NEWMAR CORPORATION WARRANTY DEPARTMENT

TECHNICAL SERVICE BULLETIN																	
DATE ISSUED	MODEL YEAR(S) AFFECTED		MODEL(S) AFFECTED			TSB #											
10/11/2013	2013 & 2014		King Aire, Essex & Mountain Aire			407											
BRAND						TYPE											
All	<input type="checkbox"/>	American Star	<input type="checkbox"/>	Mountain Aire	<input checked="" type="checkbox"/>	All	<input type="checkbox"/> TT <input type="checkbox"/>										
Cypress	<input type="checkbox"/>	Dutch Star	<input type="checkbox"/>	Kountry Aire	<input type="checkbox"/>	FW	<input type="checkbox"/> CA <input type="checkbox"/>										
Northern Star	<input type="checkbox"/>	Kountry Star	<input type="checkbox"/>	Essex	<input checked="" type="checkbox"/>	DP	<input checked="" type="checkbox"/> DB <input checked="" type="checkbox"/>										
Scottsdale	<input type="checkbox"/>	King Aire	<input checked="" type="checkbox"/>	London Aire	<input type="checkbox"/>												
All Star ME	<input type="checkbox"/>	Ventana	<input type="checkbox"/>	Bay Star	<input type="checkbox"/>

G-2000/NOVA AWNING (ECO) ENGINEERING CHANGE ORDER

12 Volt Motion Sensor Upgrade Announcement

Figure 1

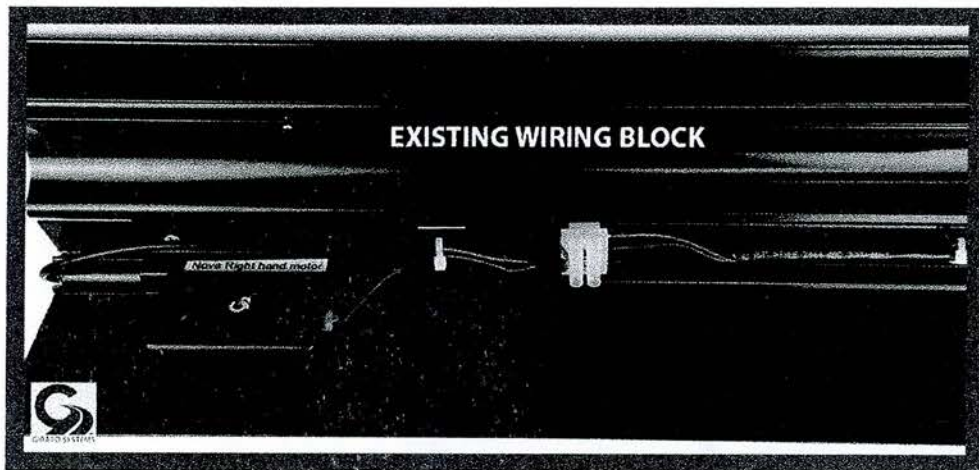
- A. Locate the wiring block that is supplying the motion sensor and led lighting system 12V power (if present). This should be located on the far right or far left side of the awnings' Lead Rail. (Figure 1)
- B. Make sure the 12V power has been shut off.
- C. Cut cable ties and remove wires from the existing wiring block making sure not to damage or cut any wires. Remove screws retaining the wiring block, and make sure to discard screws and old wiring block.

Figure 2

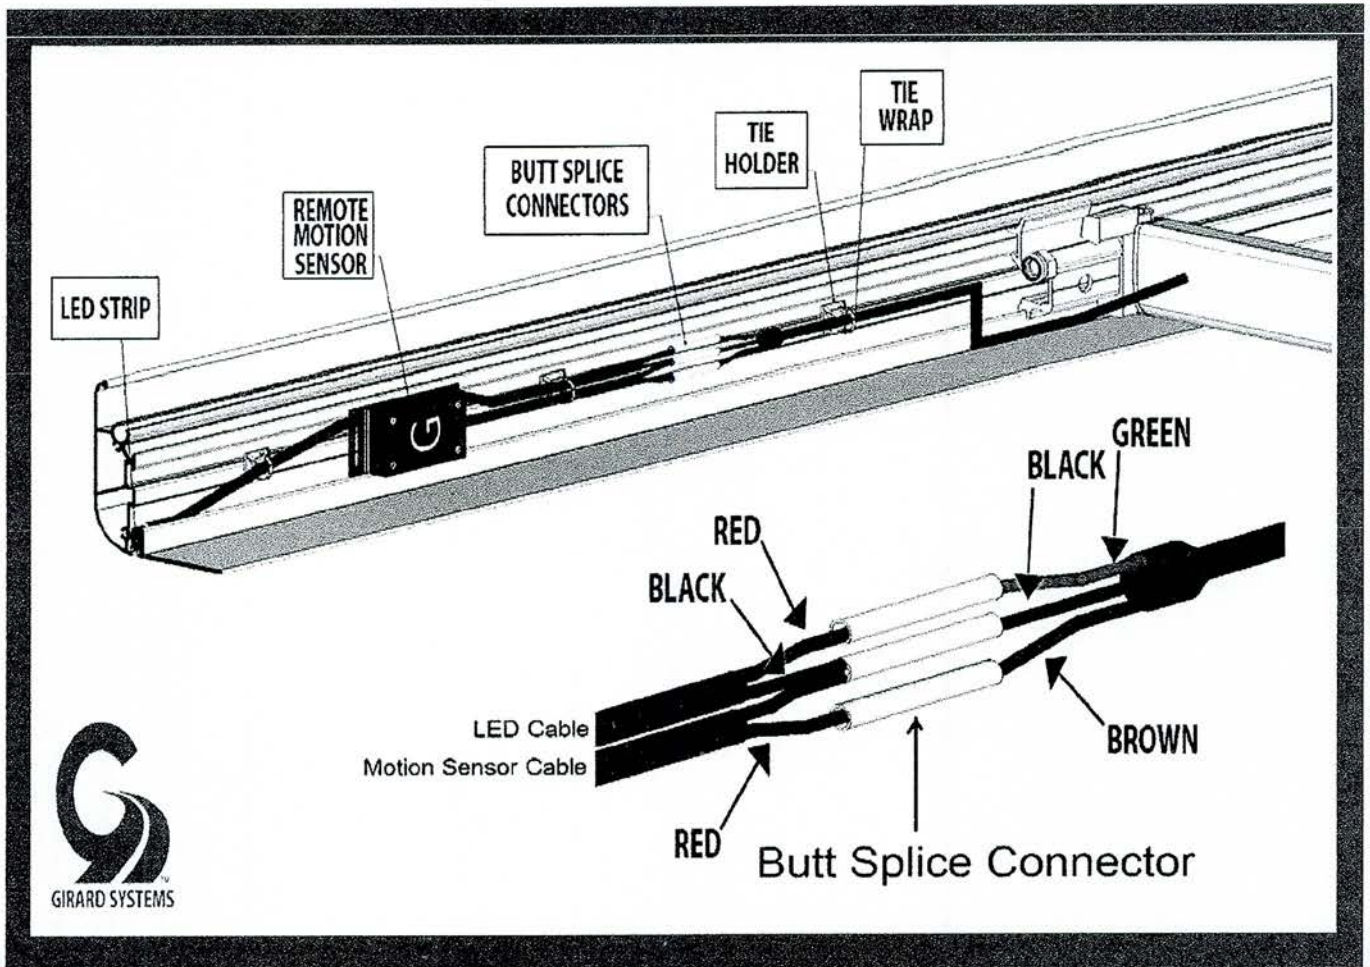
- L. Continue to the Motion Sensor and LED Lights wiring (if present). Make connections according to Figure 2. Ensure all connections are secure and tight.
- M. Return the 12V Power to the coach and test the Motion Sensor by shaking the Lead Rail of the awning; the awning should retract. Test the LED LIGHTS (if present).
- N. Once all connections have been made and tested, remove the 12V Power. Apply a heat source to the connectors to activate the thermal ends. The material should snug around the wire creating a waterproof seal.

Figure 3

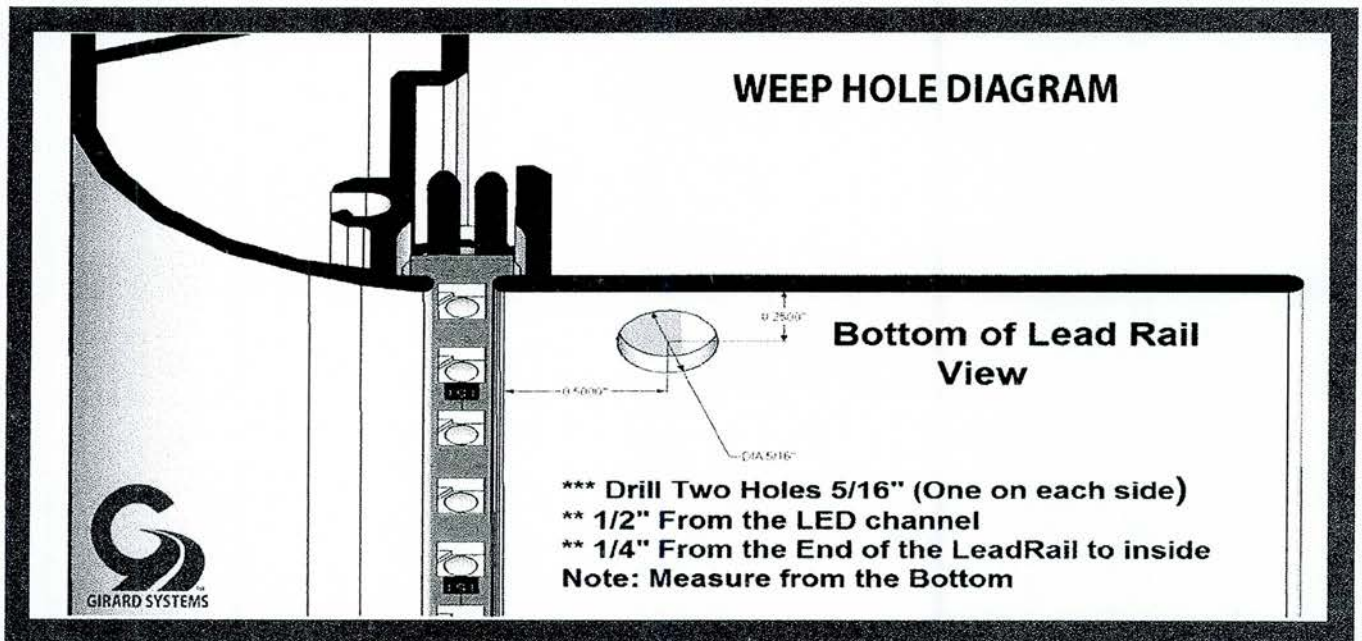
B. Drill 5/16" hole on each end of the NOVA Awnings' Lead Rail. Drill from the bottom side of the Lead Rail. Ensure that a sharp drill bit is used.
